**Origination Form**  
Proposed Revisions to a Standard Plans Index

<b>Originator:</b>	Turley, Joshua	<b>Index Number:</b>	102-201
<b>Date:</b>	6/17/2025	<b>Sheet Number(s):</b>	1-5
<b>E-mail:</b>	Joshua.Turley@dot.state.fl.us	<b>Index Title:</b>	Temporary Acrow 700XS Series Detour Bridge General Notes and Details

LAST REVISION 11/01/20 11/01/25	DESCRIPTION: 2026-27 FIXED END - BEARING DETAIL	FY <del>2025-26</del> STANDARD PLANS	TEMPORARY ACROW SERIES 700XS DETOUR BRIDGE BEARING LAYOUT AND DETAILS	INDEX 102-201	SHEET 4 of 5
---------------------------------------	--	---	--	------------------	-----------------

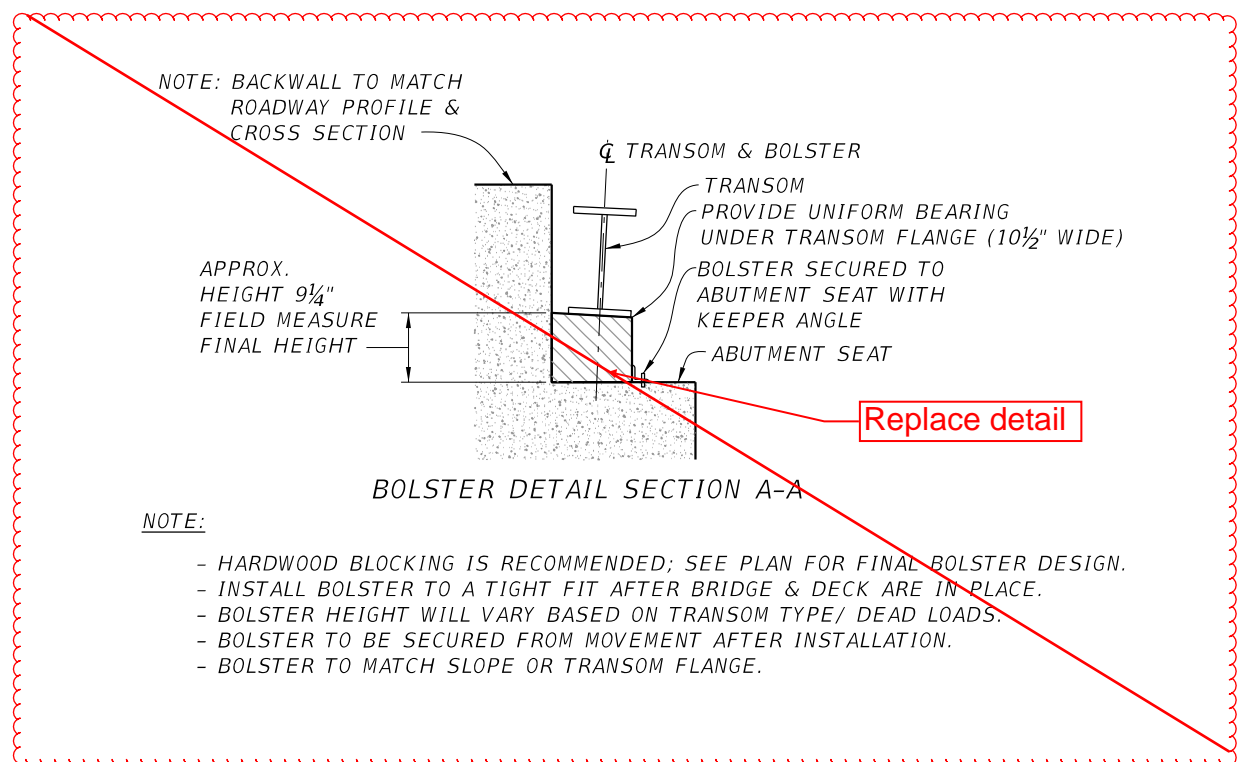
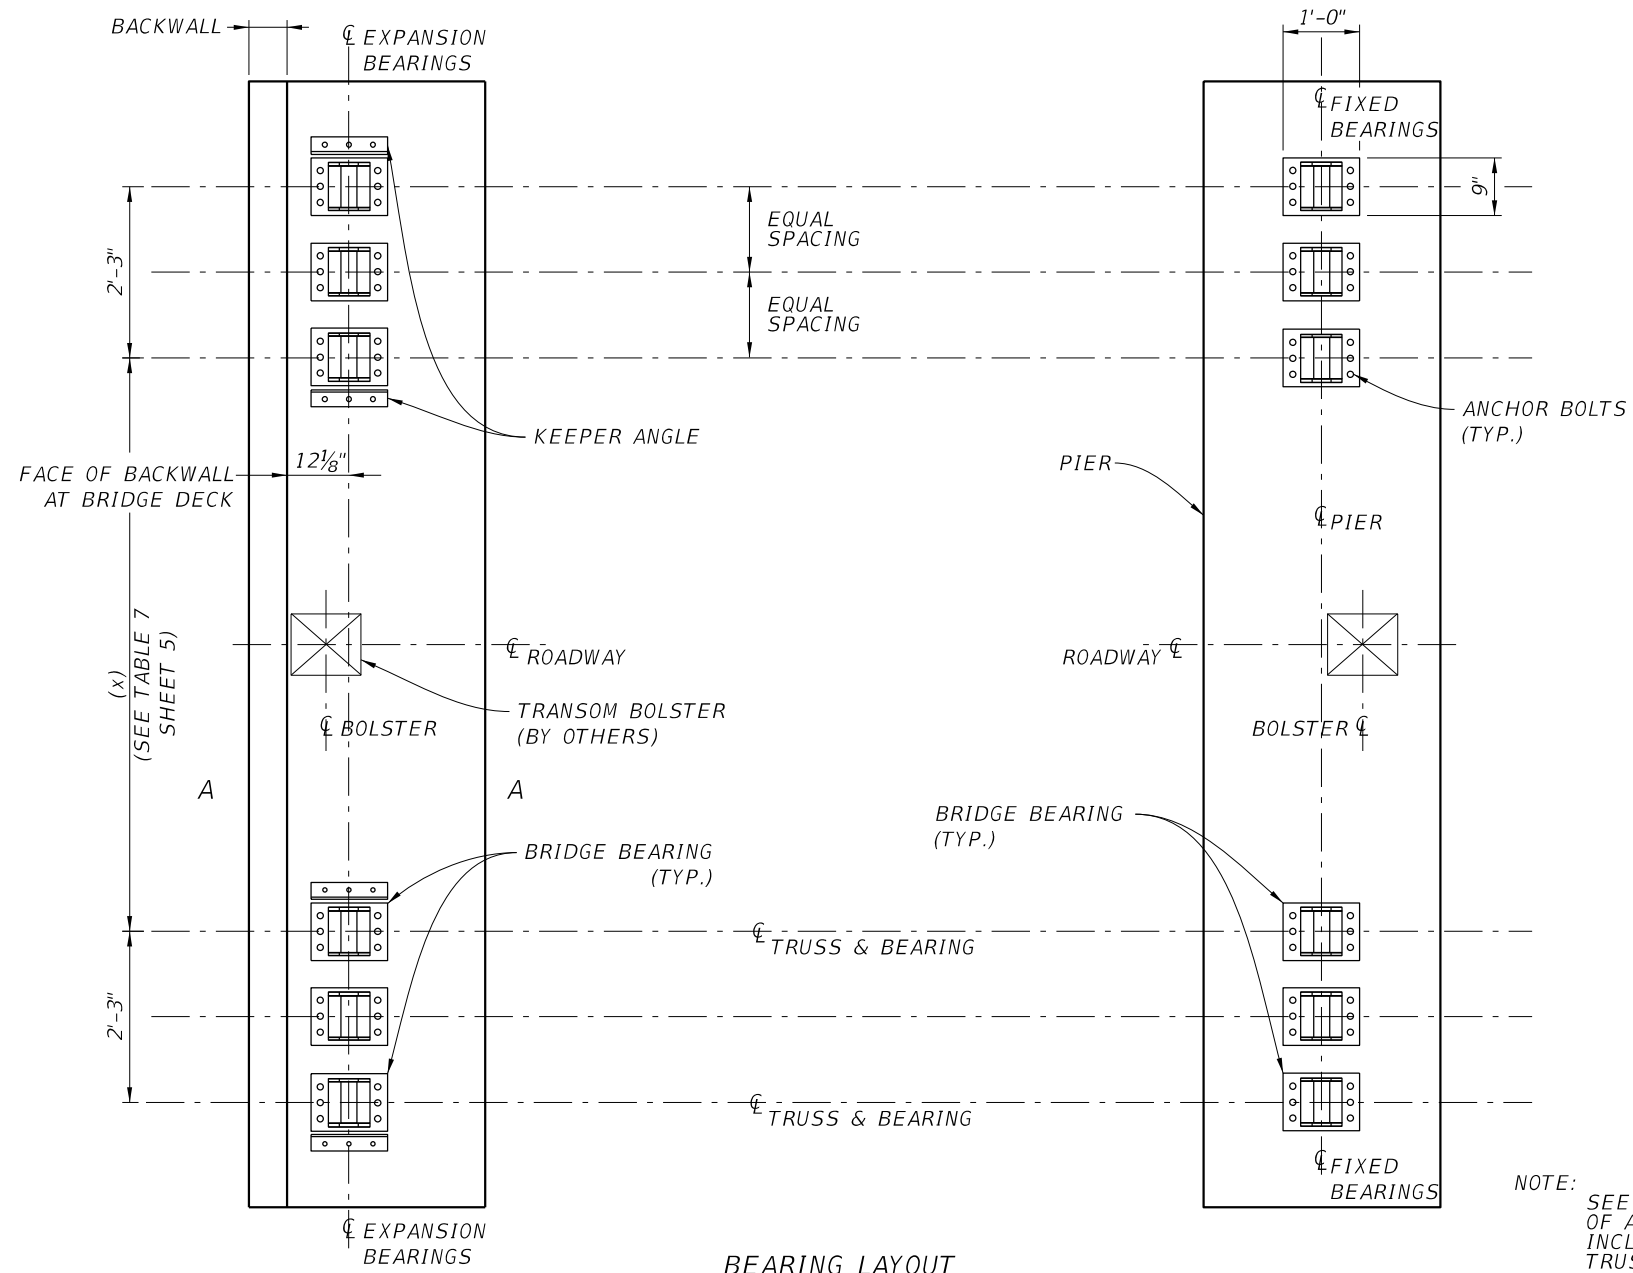
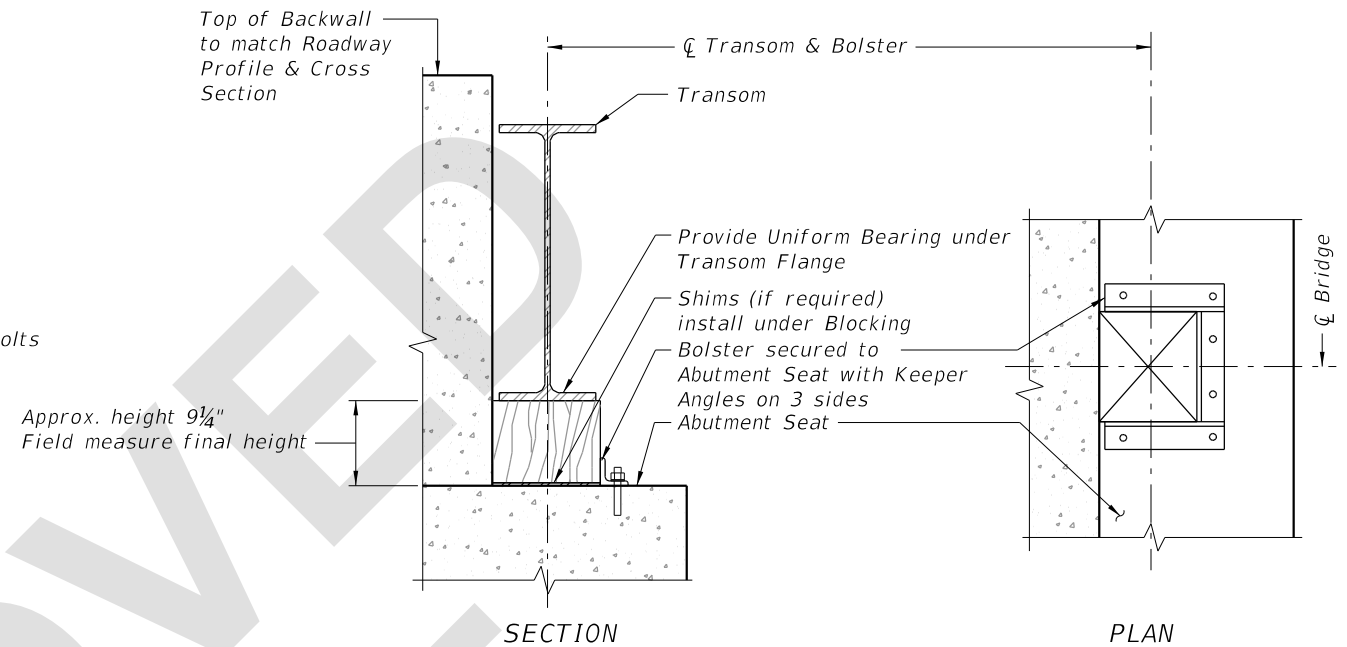
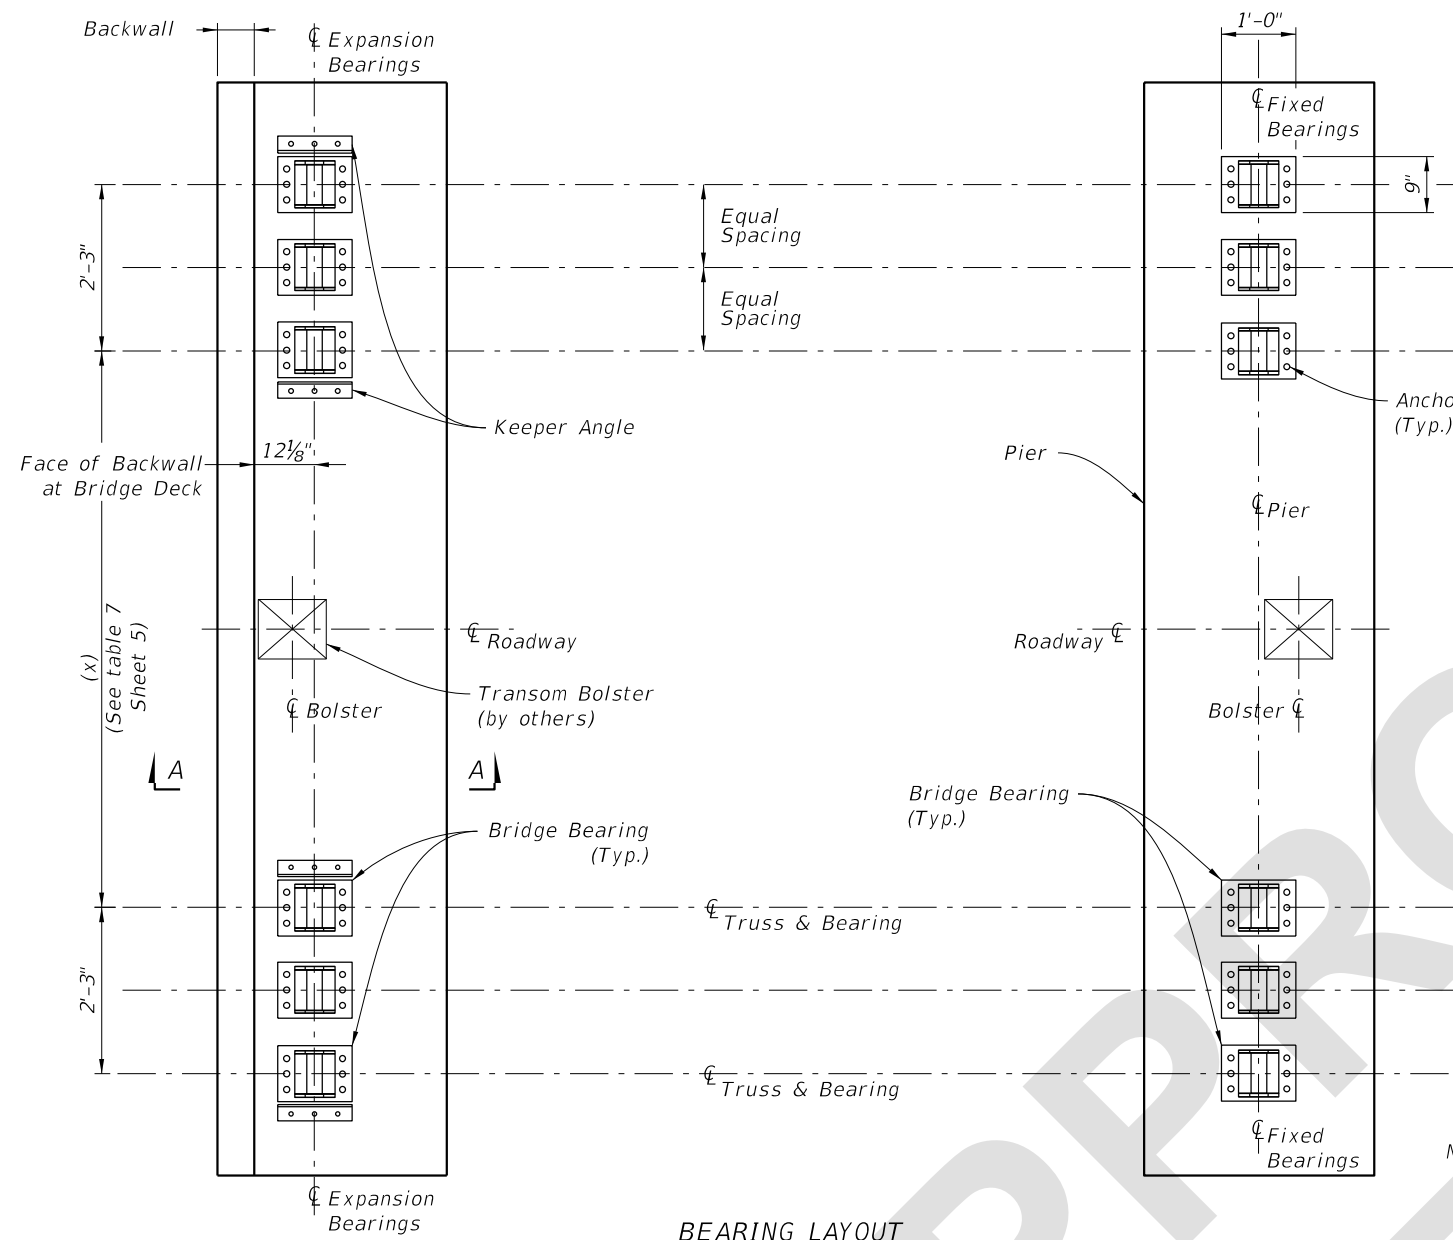
Sheet 4: Updated BOLSTER DETAIL with new detail provided by ACROW

- NOTE:**
- HARDWOOD BLOCKING IS RECOMMENDED; SEE PLAN FOR FINAL BOLSTER DESIGN.
  - INSTALL BOLSTER TO A TIGHT FIT AFTER BRIDGE & DECK ARE IN PLACE.
  - BOLSTER HEIGHT WILL VARY BASED ON TRANSOM TYPE/ DEAD LOADS.
  - BOLSTER TO BE SECURED FROM MOVEMENT AFTER INSTALLATION.
  - BOLSTER TO MATCH SLOPE OR TRANSOM FLANGE.

1. Hardwood Blocking is recommended; See Plan for final Bolster Design.
2. Install Bolster to a tight fit after Bridge & Deck are in place.
3. Bolster height will vary based on Transom Type/ Dead Loads.
4. Bolster to be secured from movement after installation.
5. Bolster to match Slope or Transom Flange.

SECTION A-A  
(Double High Truss shown, Single High Truss Similar)

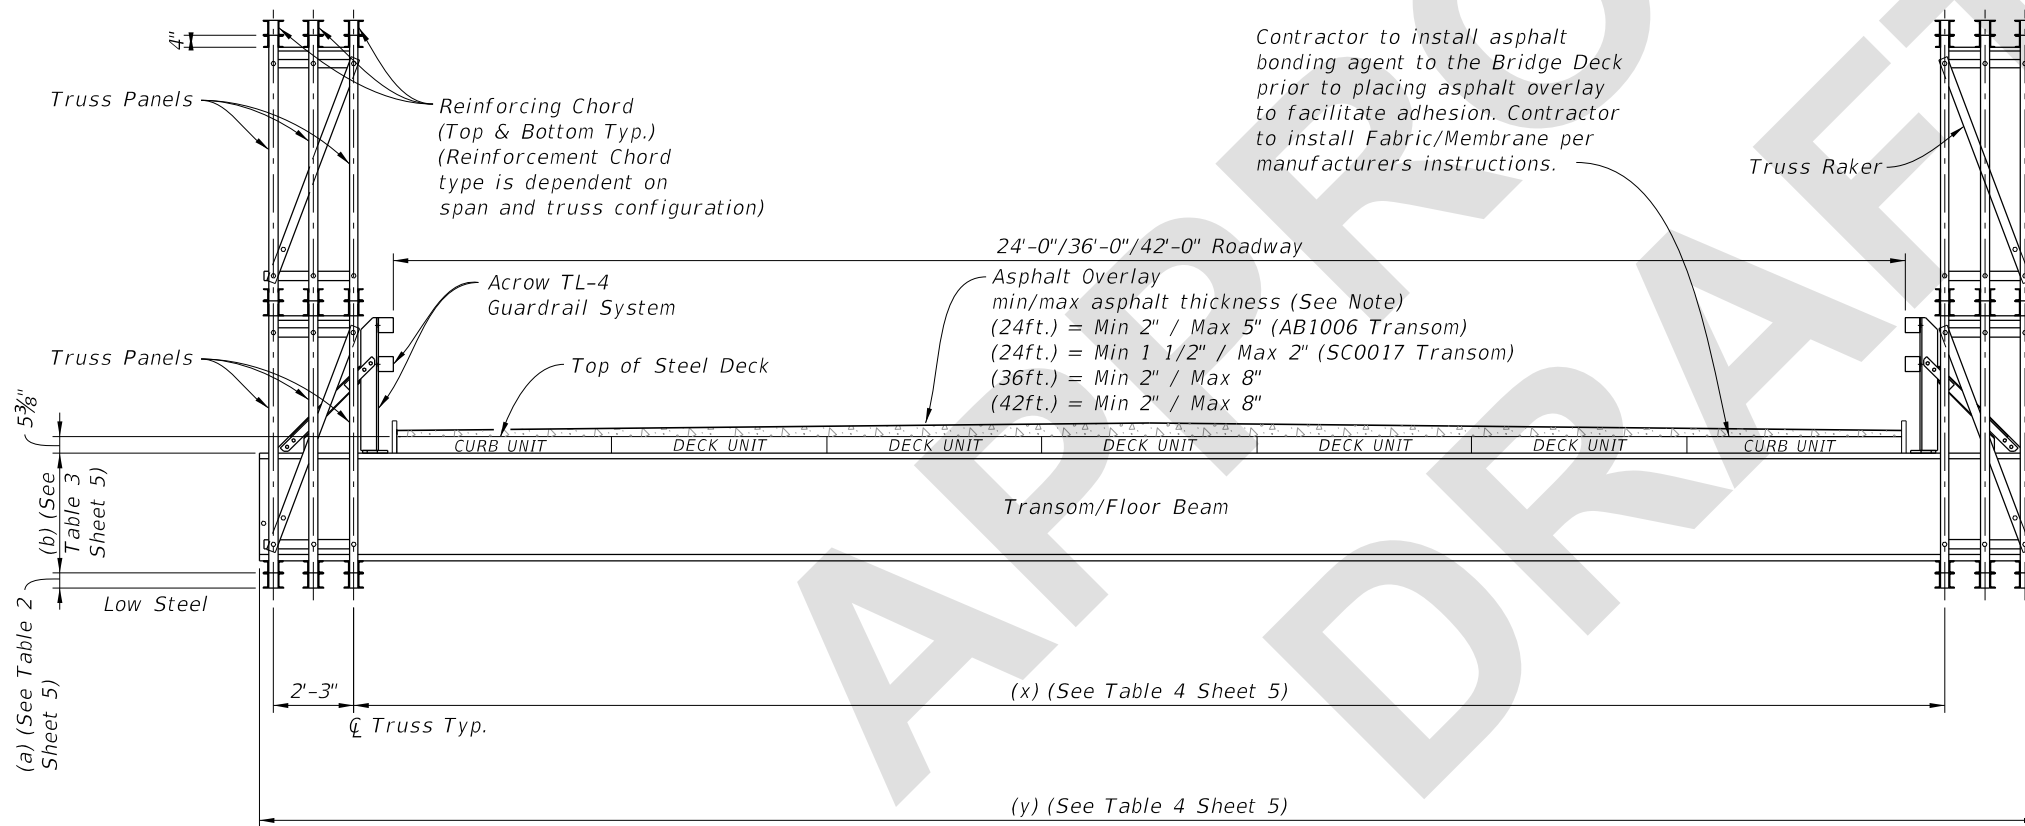
Sheet2: Added some clarifying language to asphalt overlay notes in SECTION A-A.

NOTES: See Acrow Technical Handbook and parts list for item number details. Asphalt overlay thickness shown is for when using plain steel deck.
